# Access Compliance Report

## Public Rights-of-Way

| Intersection ID: 25377                  | Main Street: BRIGMORE_DR | Cross Street: CARMEL_RD                 | Location: S            |
| ADA ID: 586BD3DC548A                    | Ramp Type: PerpDiag      | Initial Pass/Fail: Fail                 | Overall Compliance: No |

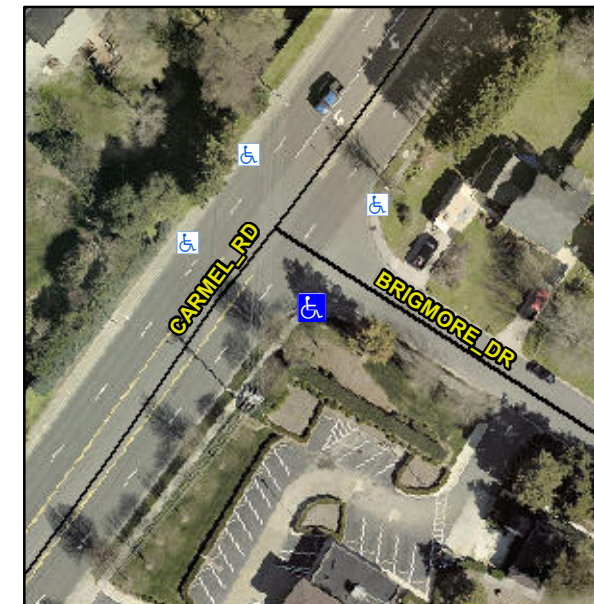
**Not Found, R304.5.1, R304.2.2, R304.5.3**

| Compliance | Description           | Data  | Compliance | Description                 | Data  |
|------------|-----------------------|-------|------------|-----------------------------|-------|
| N/A        | Ramp Length (in)      | 59.0  | No         | Ramp Slope (%)              | 13.5  |
| No         | Ramp Width (in)       | 41.0  | No         | Ramp XSlope (%)             | 4.9   |

**Remove & Replace Curb Ramp With Two New Directional Ramps or Equivalent.**
